## GS Yuasa SWL1100FR Lead Acid Battery: reports of smoking and electrical fires in UPS systems

Reference: EFN2501

### Technical Statement on SWL1100FR

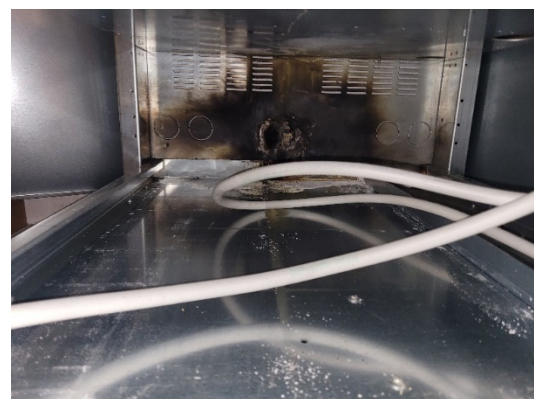
GS Yuasa were made aware that a small number of UK manufactured SWL1100FR lead acid batteries were found with a fissure on the corner of the battery container. Electrolyte leakage via this fissure results in localised corrosion to the battery shelf or tray. On occasion this has resulted in earthing (a "short"), causing blackening of the battery container and smoke.

- Customer Recommended Preventive Action** - At maintenance visits check each battery shelf visually for signs of corrosion and additionally test for earthing by looking for either voltage or continuity between the battery string and the shelf it is placed upon. If any earthing, smoke or blackening is observed, the system should be isolated and reported to your local GS Yuasa contact (see Enquiries section for contact details).
